**STAFF REPORT  
SPECIAL CERTIFICATE OF APPROPRIATENESS  
FOR THE PROPERTY AT  
1139 VENETIA AVENUE  
A LOCAL HISTORIC LANDMARK**

COA (SP) 2026-010

April 23, 2026

**Figures 1: 1940s Photo**

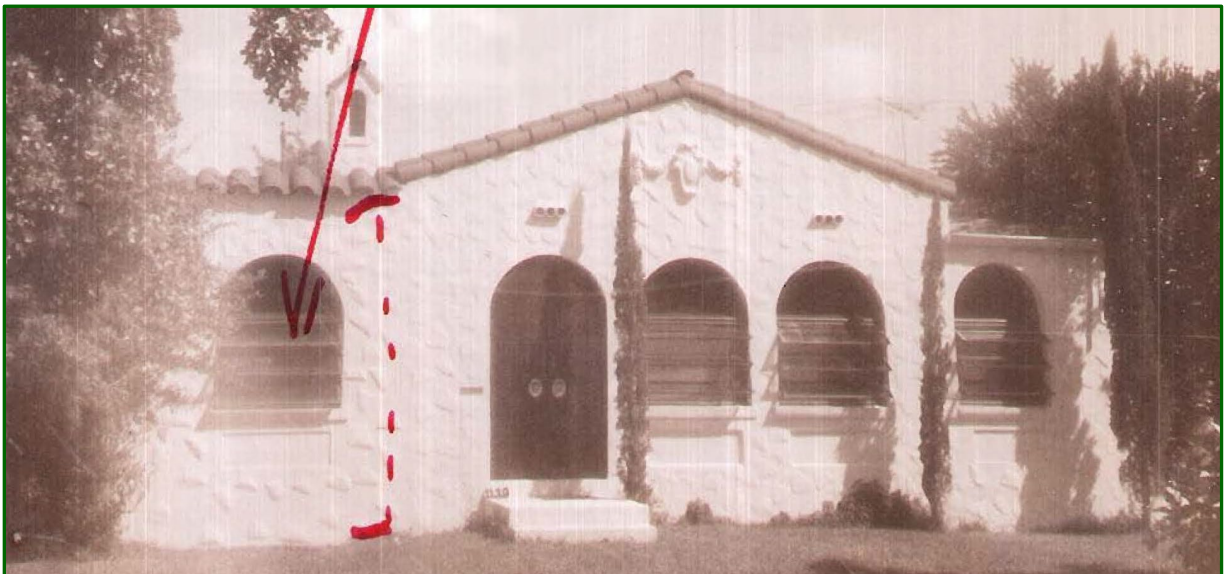
The site is a through-lot that has street frontage on Venetia Avenue at the front and Venetia Terrace at the rear. A carport facing Venetia Avenue was previously enclosed and the driveway removed, eliminating any parking at the front elevation. As it exists, the site has no covered parking but the owner plans to restore the detached garage facing Venetia Terrace. Given the existing conditions at the front, staff would recommend restoring the carport arched opening to differentiate it from the other windows and doors at the front elevation and reconfigure the proposed driveway and walkway to match 1940s photo. As proposed, the driveway is too wide and does not relate to the original carport configuration.

carport arched opening to differentiate it from the other windows and doors at the front elevation and reconfigure the proposed driveway and walkway to match 1940s photo (Figure 1). The applicant can work with staff, if there are any concerns or major modifications additional board review may be required.

1. Work with staff on restoring the garage opening at the front elevation and reconfigure the proposed driveway and walkway to match 1940s photo, leading into the carport.
2. Work with staff to find a window configuration for the enclosed carport openings to complement the style of the building.
3. Maintain the original window opening sizes at the master bedroom.
4. Window/door muntins are to be high-profile / dimensional.
5. Window/door glass to be clear / no tint / no reflectivity / no low-e.
6. Stucco is to be differentiated from the existing home. Staff to review a sample for approval prior to application.
7. Stucco on the original structure is to remain and not be restuccoed.
8. Roof tile is to be a true- two-piece barrel tile.
